***VIRGINIA DEPARTMENT OF ENVIRONMENTAL QUALITY***

Re: Mountain Valley Pipeline, LLC (MVP)  
Erosion & Sediment Control (ESC) Plan Modification (2) Approvals

The Department of Environmental Quality (DEQ) hereby approves the following modifications to the Erosion & Sediment Control (ESC) Plan:

- MLV-23 and MVP-MLV-AR-23, Sheets 12.07ES and 12.08ES, Sign/Seal dated 8/14/2023, Sheet 12.08PC, Sign/Seal dated 12/7/2022.
- MLV29, H602/H-603 Tap Sites, Details 33.1-33.4, Sheet 14.34ES, Sign/Seal dated 3/30/2022, Sheets 15.78 ES, 15.91ES, Sign/Seal dated 5/5/2022 Sheets 15.92ES, 15.93ES, 14.34AES, Sign/Seal dated 8/14/2023.

DRAWN BY:	JZ
CHECKED BY:	RE
APPROVED BY:	TD
DATE:	05/04/2022
SCALE:	AS SHOWN
SHT. NO. 15.78ES OF	15.99ES

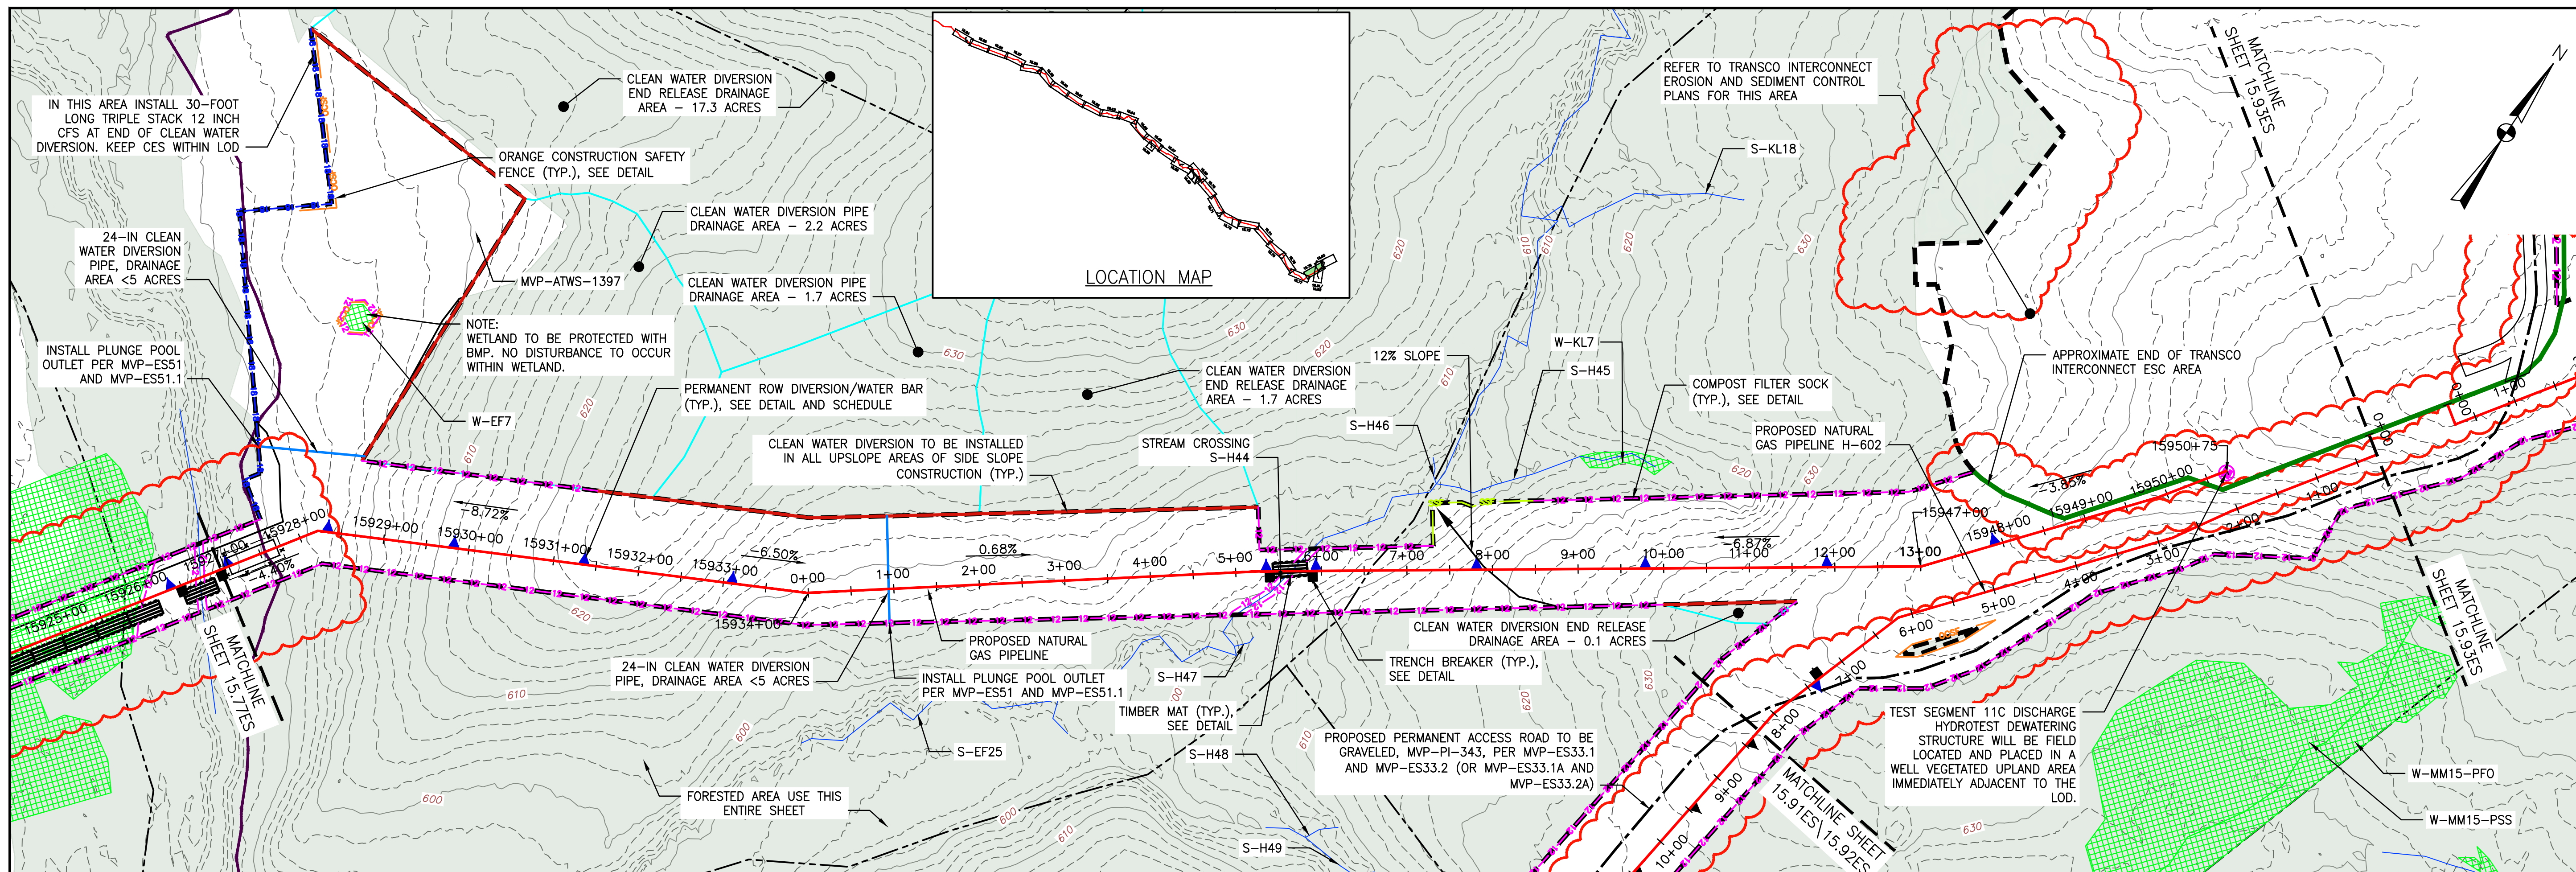
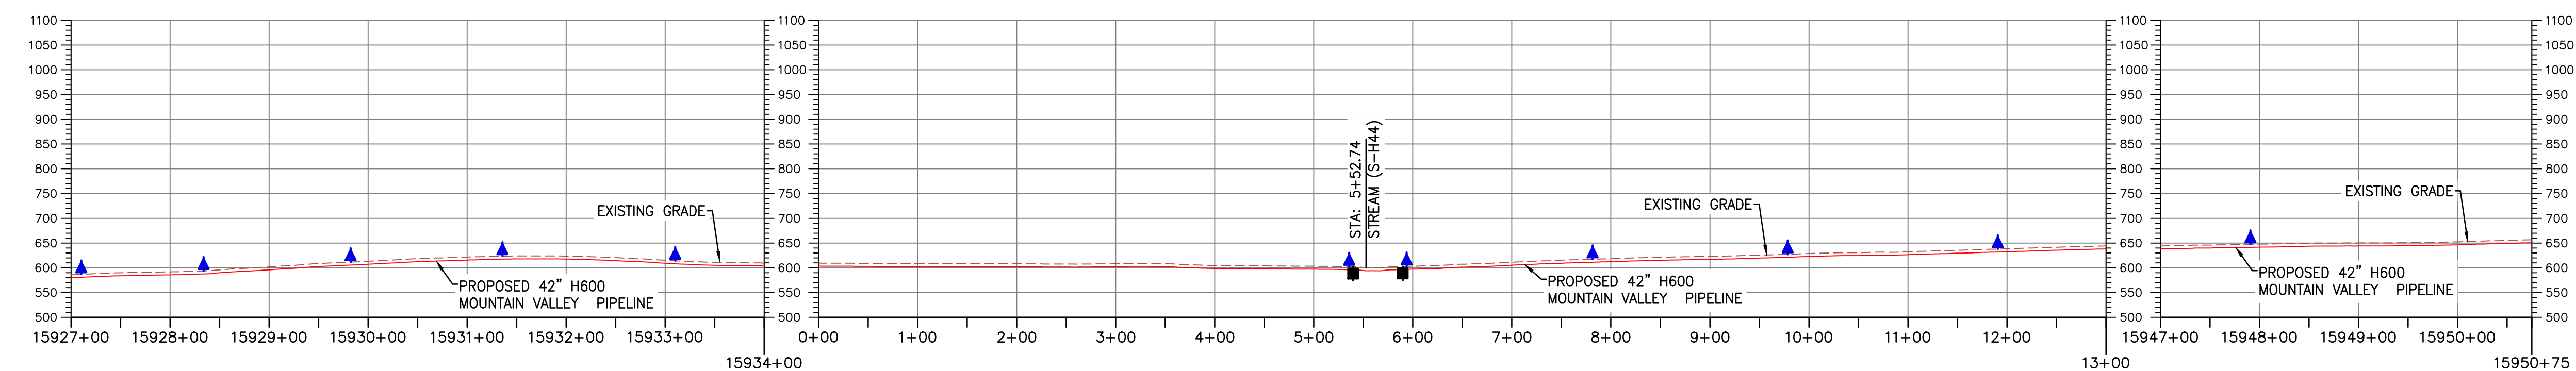
NO.	DATE	CHKD.	APPD.	DESCRIPTION
7	05/04/22	JZ	RE	UPDATED MVP-PI-343 ALIGNMENT AND TRANSCO LOD
6	05/04/22	JZ	RE	UPDATED TO REFLECT FINAL LOD FOR APPROVED TRANSCO INTERCONNECT SITE

DRAWN BY:	JUZ
CHECKED BY:	RE
APPROVED BY:	TD
DATE:	05/05/2022
SCALE:	AS SHOWN
SHT. NO. 15.91ES OF	15.99ES

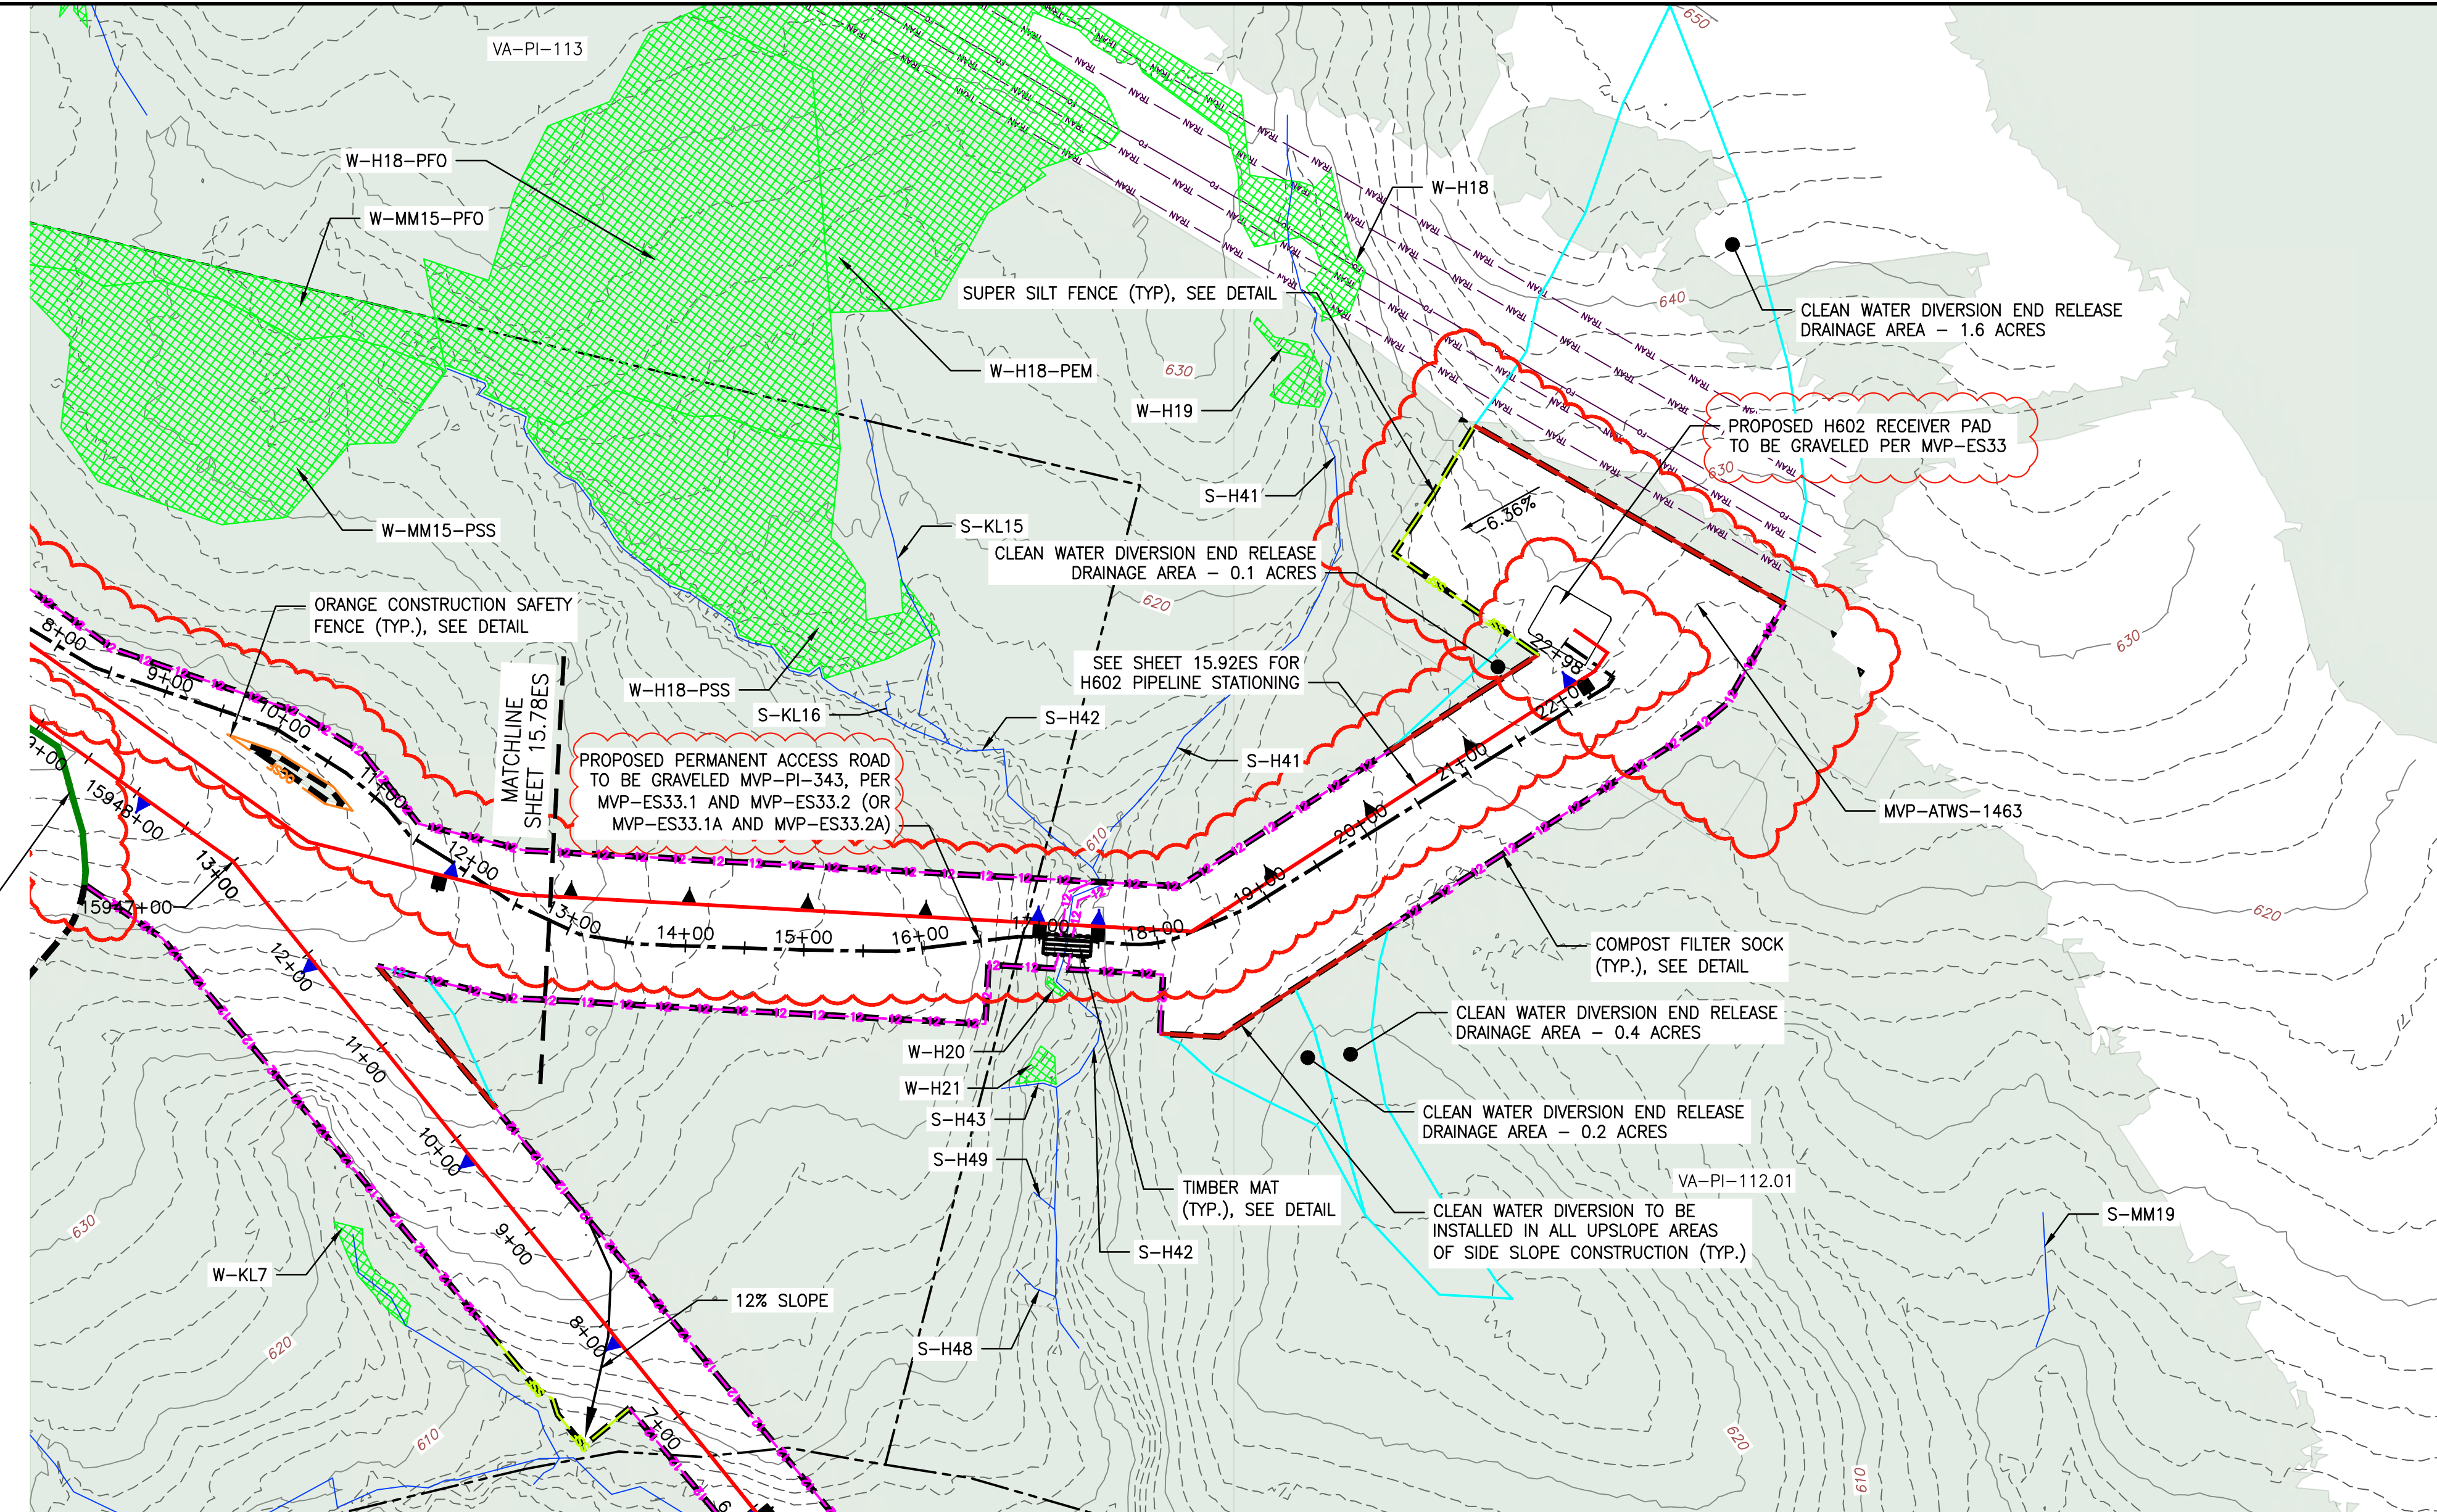
NO.	DATE	CHKD.	APPD.	DESCRIPTION
1	05/05/22	JUZ	RE	ADDRESS VADEQ COMMENTS TO FIELD MODIFICATION SUBMITTAL
2	08/22/19	JMK	RE	ADDRESS VADEQ COMMENTS TO FIELD MODIFICATION SUBMITTAL
3	04/18/19	JMK	RE	ADDRESS VADEQ COMMENTS TO FIELD MODIFICATION SUBMITTAL
4	01/21/19	JMK	RE	FIELD MODIFICATION # 303 (WATER REGIONS SEE AND ACCESS AND MP-PI-343)
5	03/16/18	KAL	RE	ADDRESS VADEQ COMMENTS
6	03/04/18	KAL	RE	ADDRESS VADEQ COMMENTS

COMMONWEALTH OF VIRGINIA  
 David J. Wallner  
 Lic. No. 57593  
 PROFESSIONAL ENGINEER  
 DATE: 07/28/2023  
 SCALE: AS SHOWN  
 SHT. NO. 15.92ES OF 15.99ES

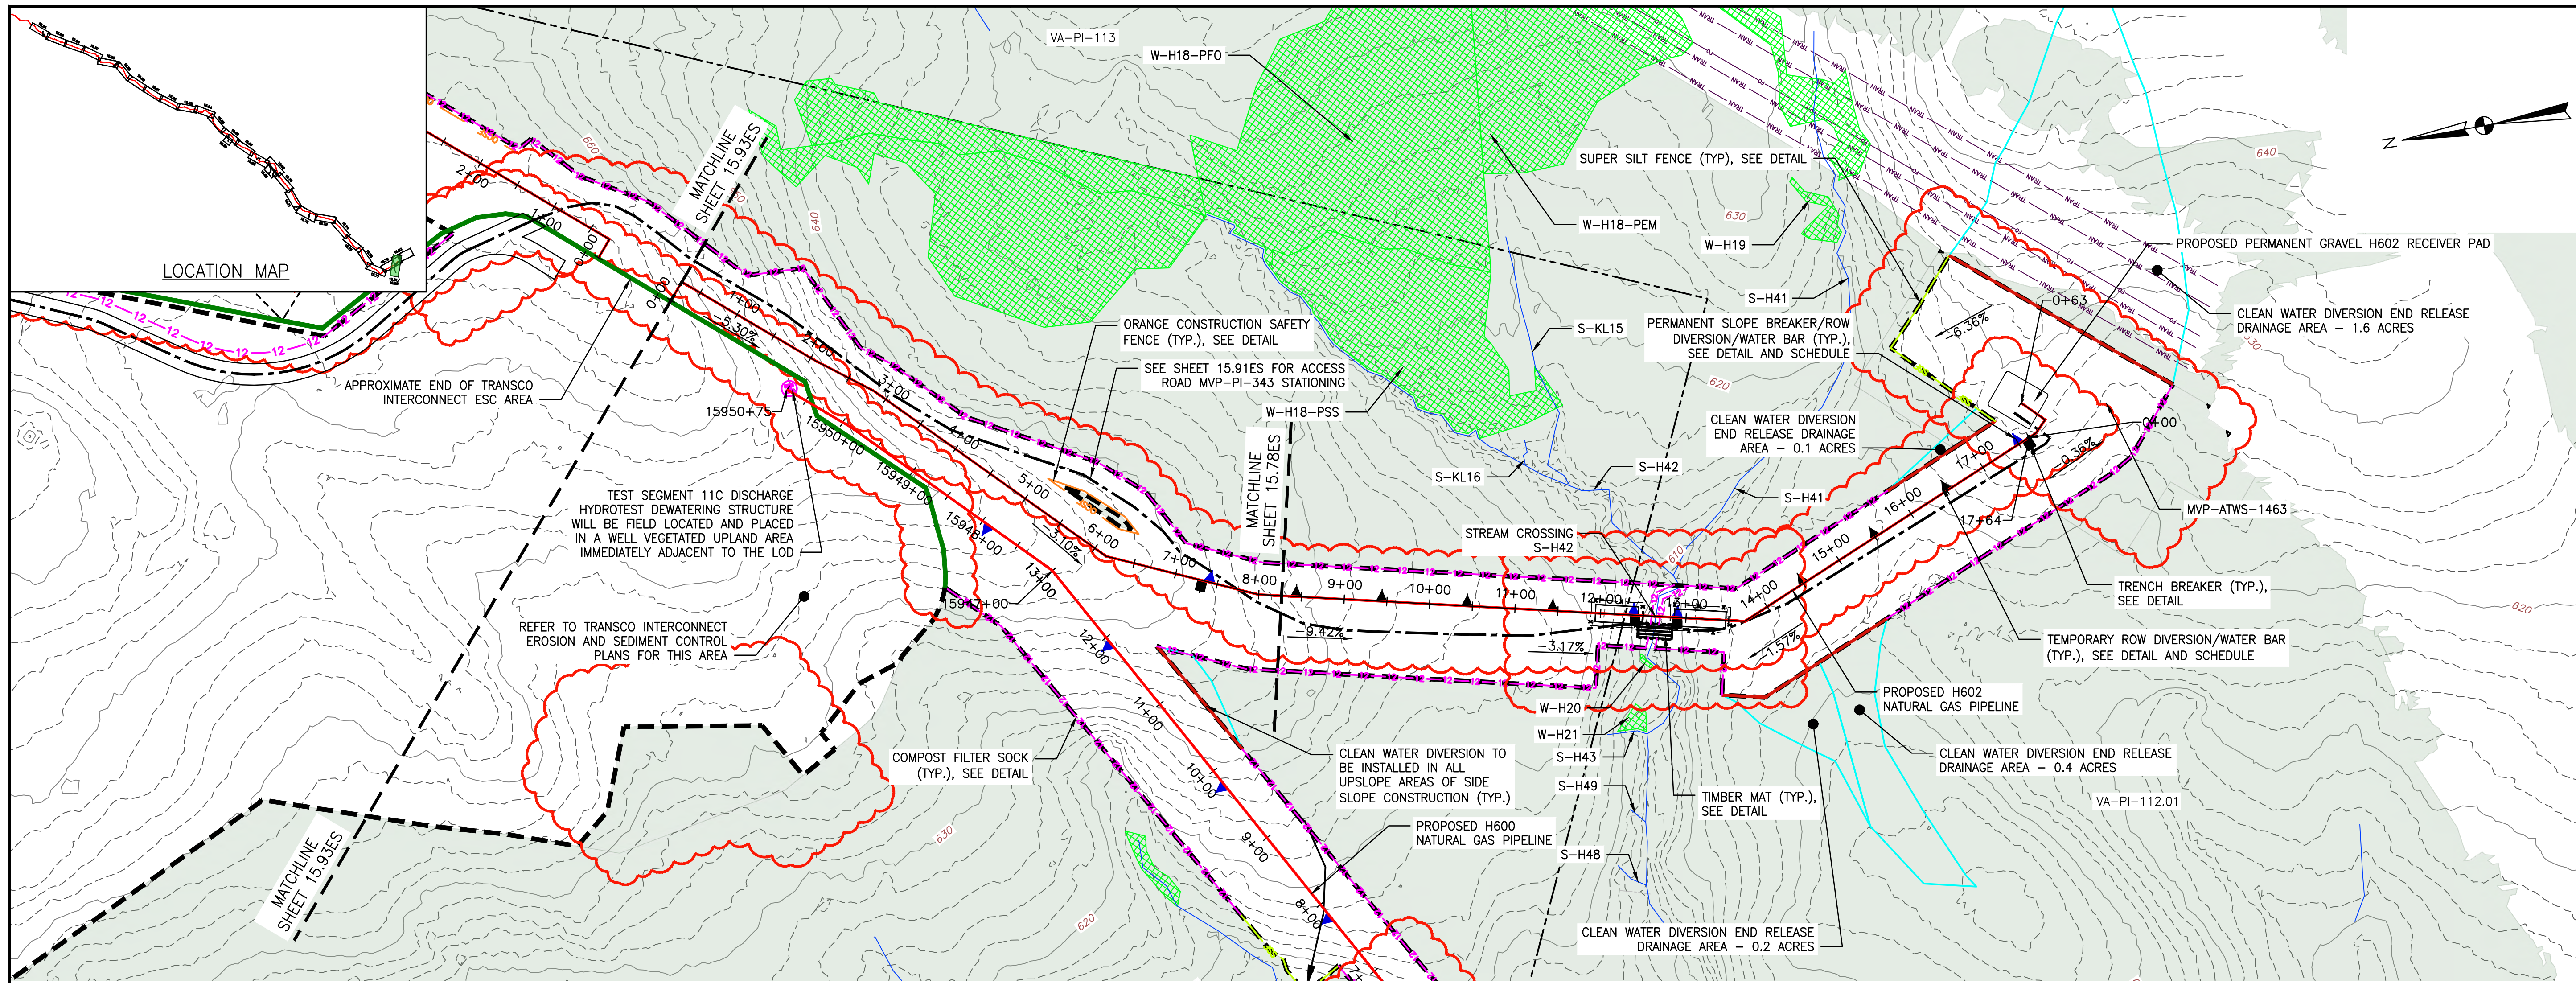
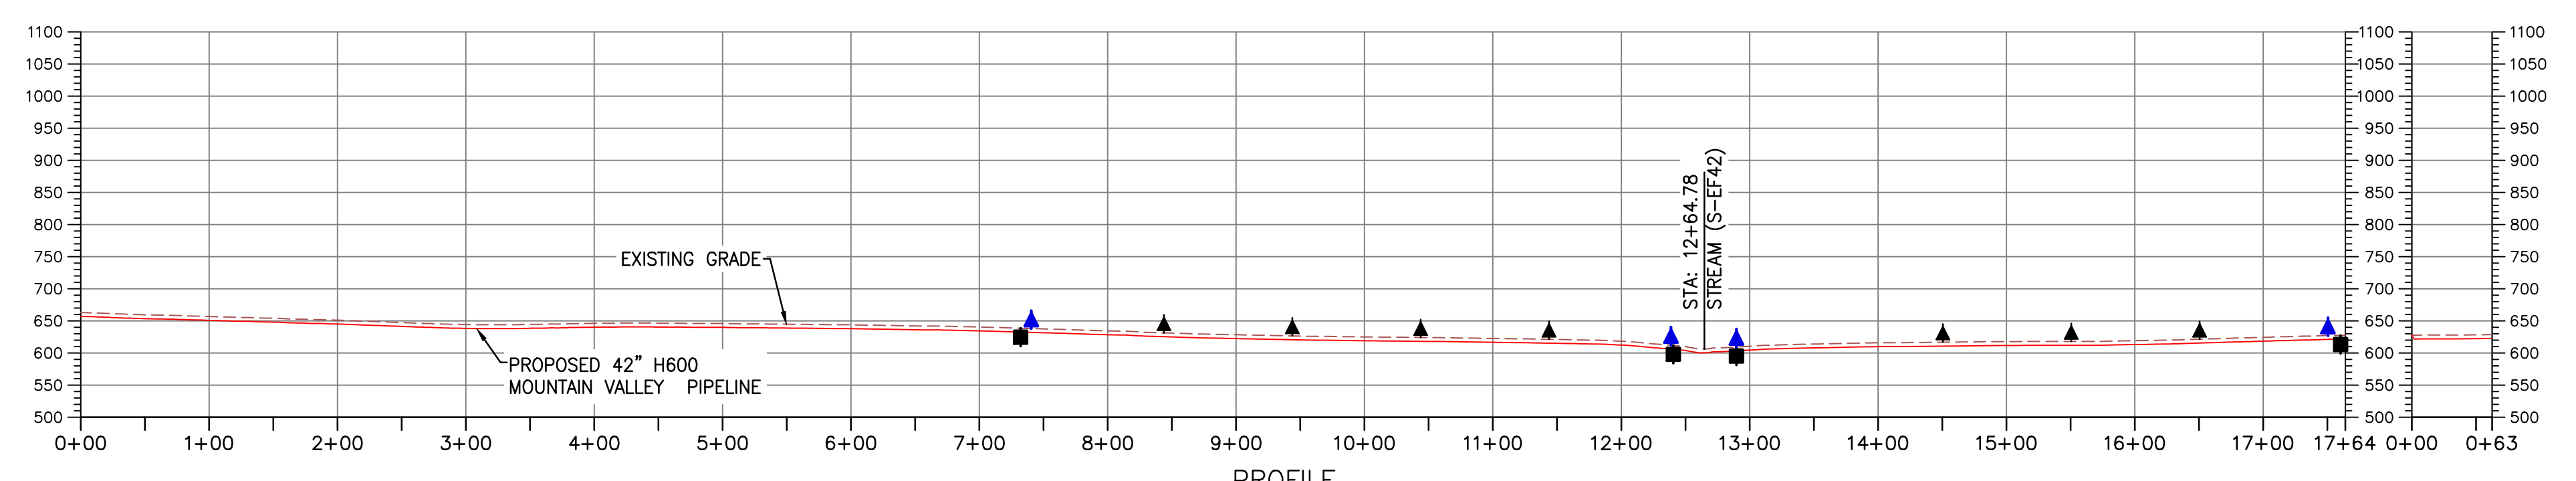
NO.	DATE	CHKD.	APPD.	DESCRIPTION
1	07/28/23	JJK	JJK	ADDRESS VADEQ COMMENTS TO FIELD MODIFICATION SUBMITTAL
2	05/05/22	JJK	JJK	ADDRESS VADEQ COMMENTS TO FIELD MODIFICATION SUBMITTAL
3	04/18/19	JJK	JJK	ADDRESS VADEQ COMMENTS TO FIELD MODIFICATION SUBMITTAL
4	01/21/19	JJK	JJK	FIELD MODIFICATION-UP 30.3 (WRC RECEIVER SITE AND ACCESS ROAD (MVP-PI-34))
5	03/16/18	KAL	JJK	ADDRESS VADEQ COMMENTS
